Redraws

RESIDENCE FOR:
MODEL
TBD
SERENITY HAVEN

Job Number: STYH-0124-00	Drawing Date: 8/4/2025	Coord Name: GREG P.	Coord Phone: 859.578.4355
House Name:			Drawn By: EWT
			Series:
			Plan No.:

0C.1
Cover Sheet
Elevation "K"

1.01

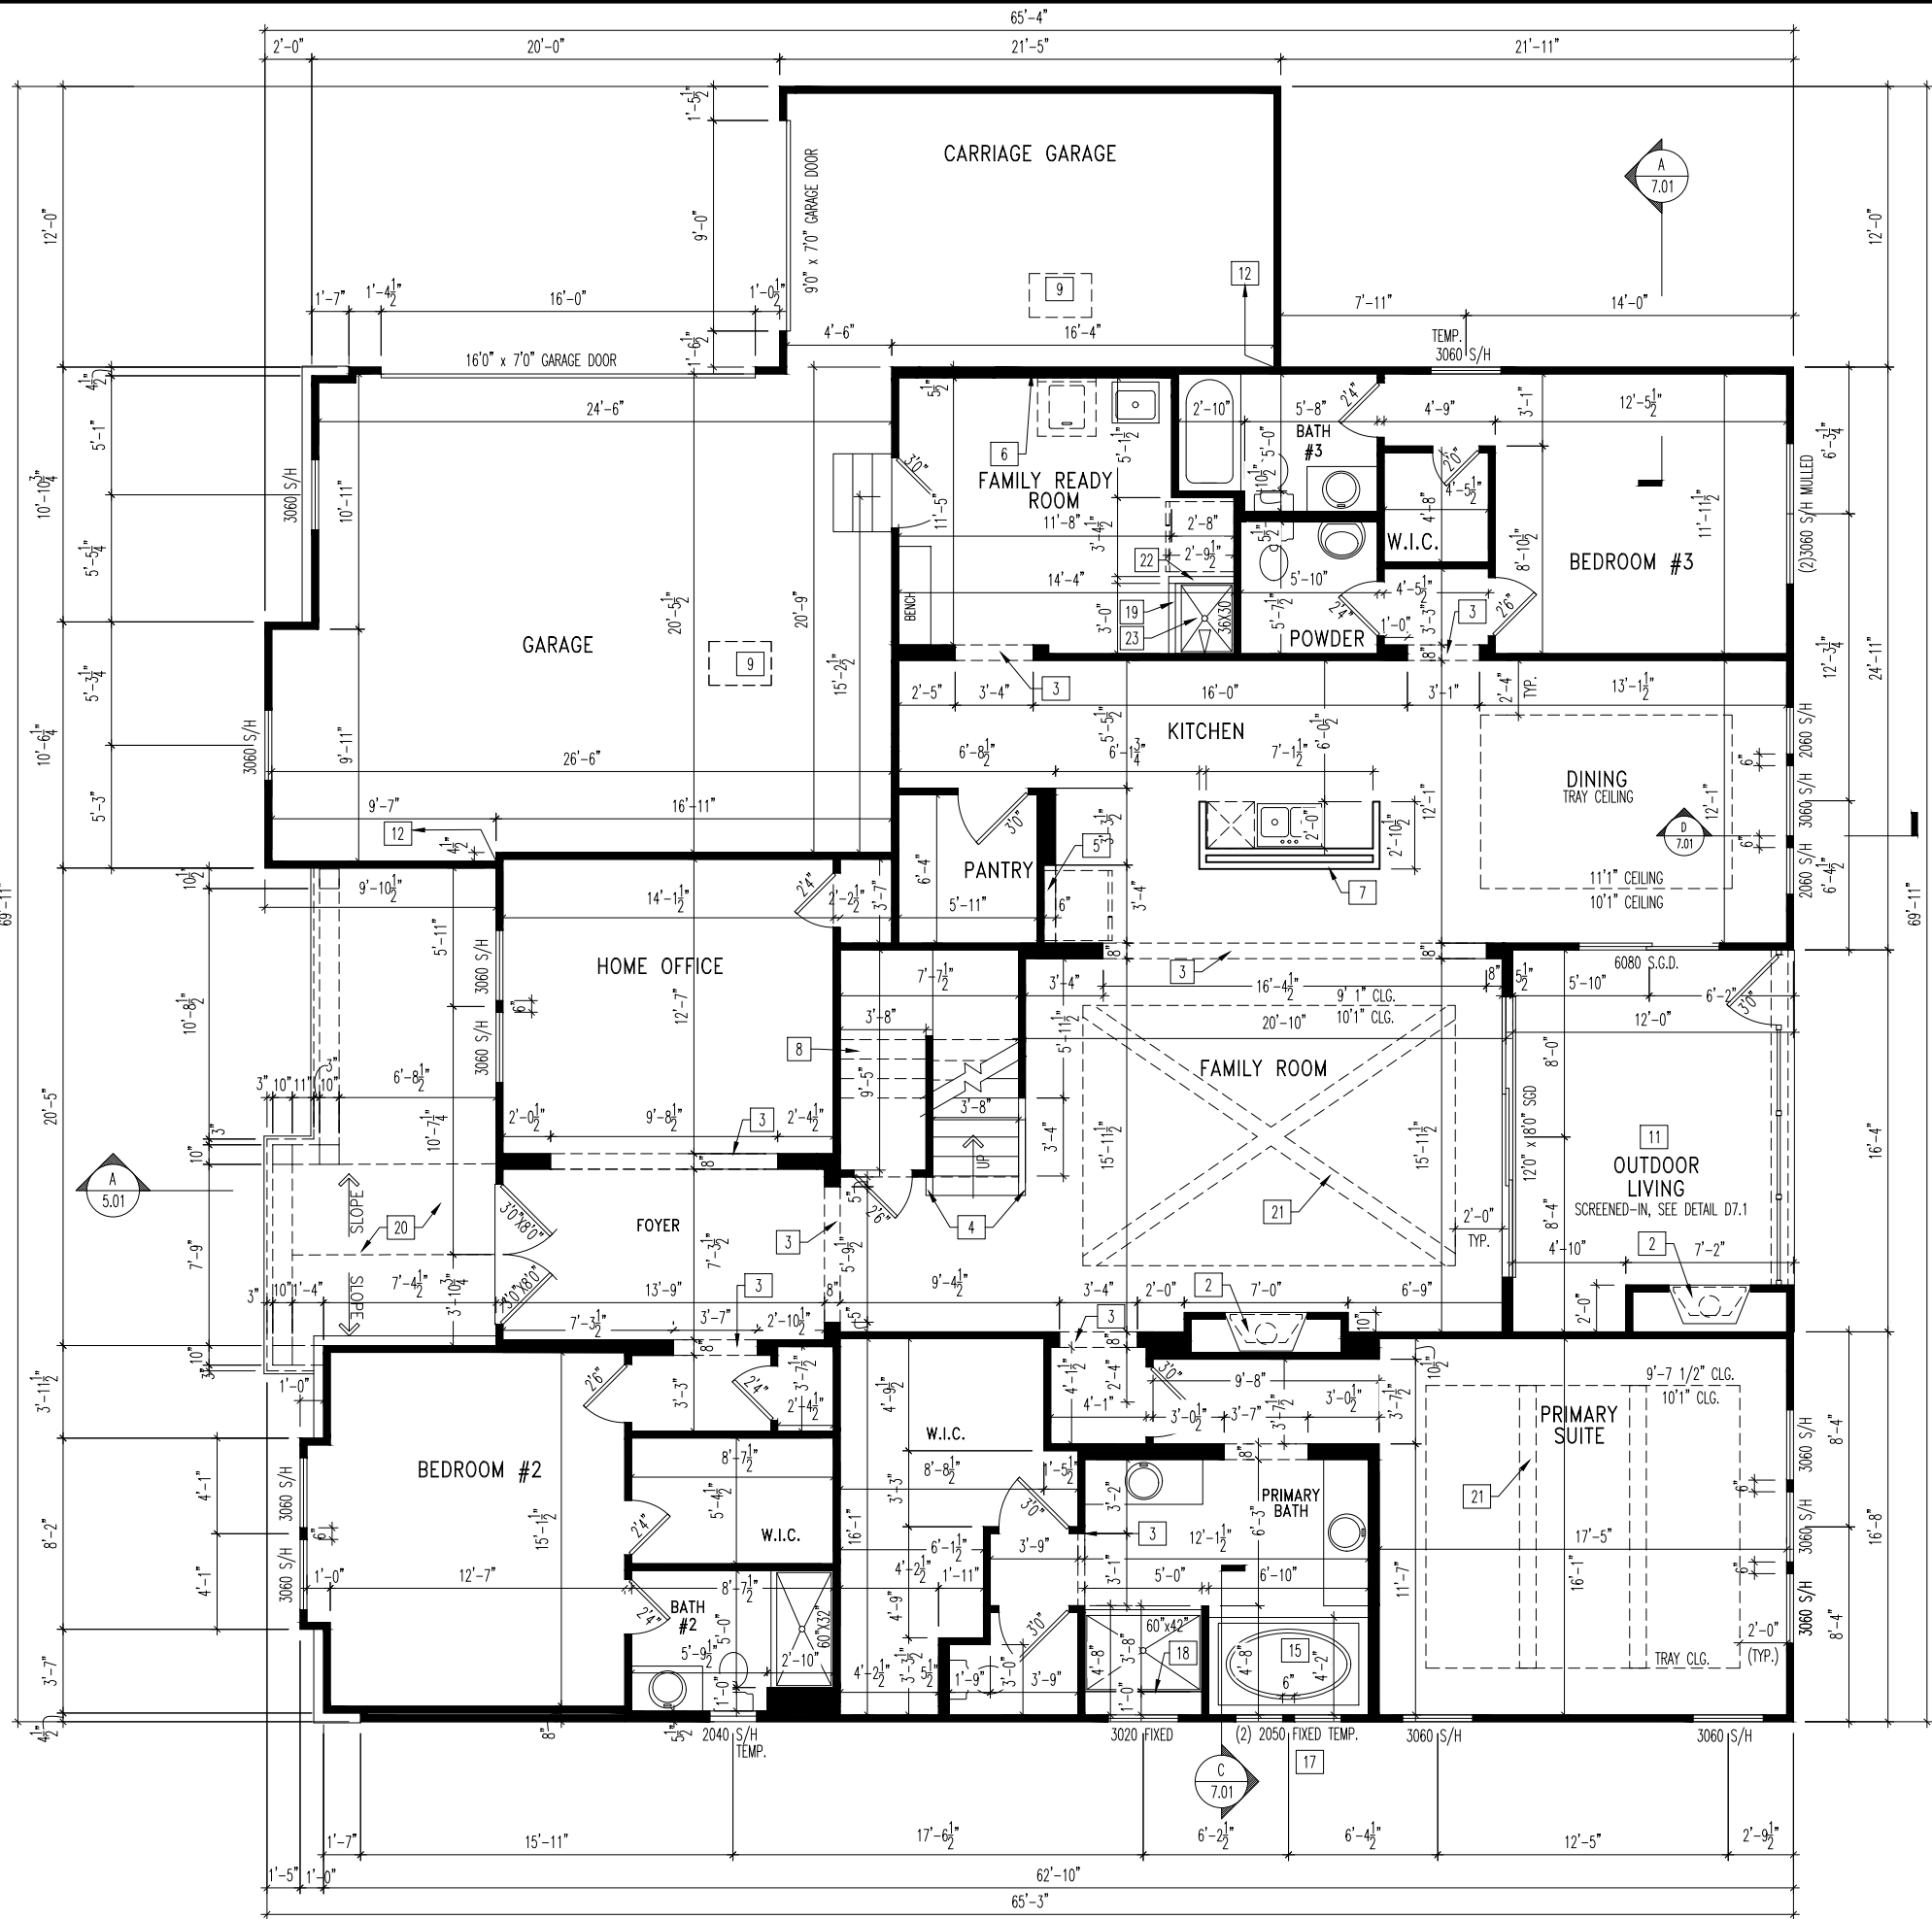
ADD MODEL SALES OFFICE, SHOW GARAGE BATH FIXTURES ON 1.01
